CONTRACT CHANGE ORDER NO. 16, SUPPLEMENT NO. 1

PROJECT NAME Evergreen Road Bridge Replacement Project SHEET 1 OF 7

FEDERAL PROJECT NO. BRLOZB 5908(025)

In accordance with Section 4-1.05, Changes and Extra Work, of the Standard Specifications, perform the following work. Modify Drainage Ditch "D15" and construct Drainage System 17 to tie into Drainage Ditch "D7" as shown on the attached plan sheets.

DITCH "D15"

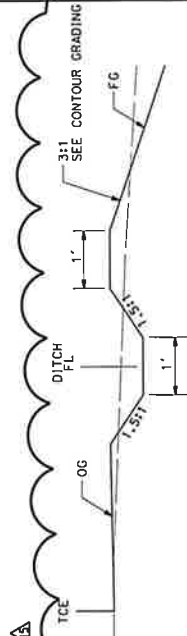
Regrade Ditch "D15" side slopes from 1:1 to 2:1 from "E" Sta 34+30 to "E" Sta 38+24.38; The lump sum price will constitute full and complete compensation, including all labor, materials, equipment, and incidentals to complete the work.

"E" Stg 38+24.38 TO "E" Stg 34+30

STATION	LINE	OFFSET	L+R/4	FLOW LINE ELEV	SLOPE
41+42.95	"E"	316.10'	R+	440.50	-0.10%
39+40.44	"E"	100.13	R+	440.18
